BOROUGH OF OCEANPORT

PLANNING/ZONING BOARD

AGENDA • AUGUST 11, 2020

Re: Preliminary and Final Site Plan
Block 127, Lot 4
MPCC II, LLC
2 Crescent Place
Borough of Oceanport, Monmouth County, New Jersey
MC Project No. OPP-268

PROJECT NUMBER: 19-001
SHEET 8 OF 14

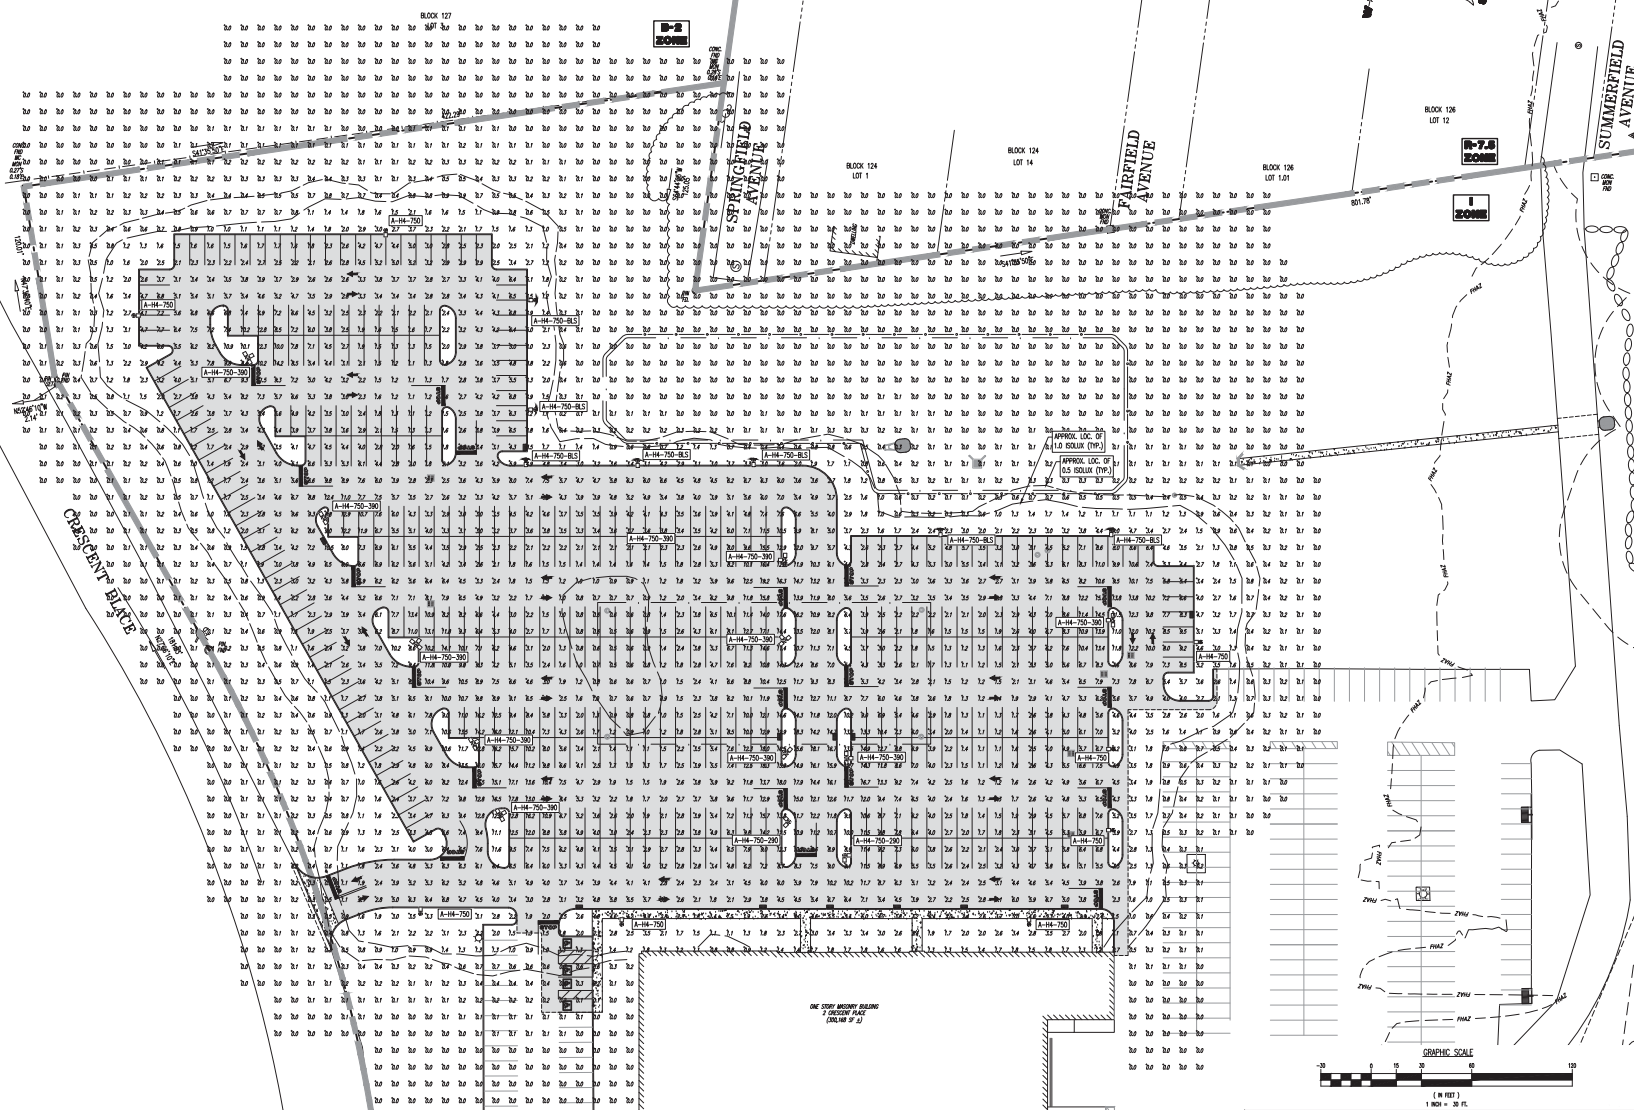
6. The common property line of Block 127, Lot 3 and the subject property, should provide groupings of evergreen trees between the shade trees to reduce visibility of cars and headlights.

7. Sheet 8 of 13 indicates that landscape notes and planting details would be provided on Sheet 11 of 13. No details or notes pertaining to landscaping was illustrated on Sheet 11 of 13. Please provide the required information moving forward.

6. The enclosed Landscape Plan has been revised to additional plantings along the Block 127, Lot 3 property line.
7. The Planting Specifications, Planting Notes, Deciduous and Evergreen Shrub Planting Detail, and Deciduous Tree Planting Detail are provided on Sheet 11.
